Access Compliance Report

Public Rights-of-Way

(Curb Ramps)

Intersection ID: 5250	Main Street: AUSTIN RIDGE LN	Cross Street: CAMERON SPRING RD	Location: S
ADA ID: 5D898976D92E	Ramp Type: Perp	Initial Pass/Fail: Fail	Overall Compliance: No
Severity Score: 22.5			
Codes/Mitigation Info/Possible Solution		Field Measurements/Component Compliance

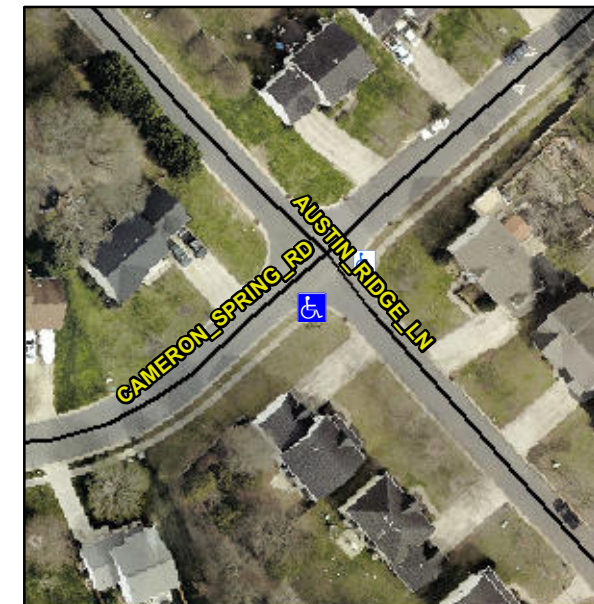
Not Found, R304.5.1, R304.2.2, R304.5.3

Compliance	Description	Data	Compliance	Description	Data
N/A	Ramp Length (in)	43.0	No	Ramp Slope (%)	8.9
No	Ramp Width (in)	41.0	No	Ramp XSlope (%)	3.3
N/A	Flare Type LT	N/A	N/A	Flare Type RT	N/A
N/A	Flare Slope LT (%)	N/A	N/A	Flare Slope RT (%)	N/A
N/A	Flare Traversable LT?	N/A	N/A	Flare Traversable RT?	N/A
N/A	Landing Length (in)	N/A	N/A	DWS Provided?	N/A
N/A	Landing Width (in)	N/A	N/A	DWS Contrast?	N/A
N/A	Landing Slope (%)	N/A	N/A	DWS Length (in)	N/A
N/A	Landing X Slope (%)	N/A	N/A	DWS Full Width?	N/A
N/A	Landing Curb? (Y/N)	N/A	N/A	DWS Offset (in)	N/A
N/A	Shared Landing?	N/A			
N/A	Gutter Ponding?	N/A	N/A	Gutter Slope (%)	N/A
N/A	Gutter Lip Ht (in)	N/A	N/A	Gutter X Slope (%)	N/A
N/A	Painted X Walk1?	No	N/A	Painted X Walk2?	N/A
	X Walk 1 Direction	To NE		X Walk 2 Direction	N/A
N/A	X Walk 1 Width (in)	N/A	N/A	X Walk 2 Width (in)	N/A
	X Walk 1 Slope (%)	4.0		X Walk 2 Slope (%)	N/A
	X Walk 1 X Slope (%)	3.2		X Walk 2 X Slope (%)	N/A

Remove & Replace Entire Ramp.
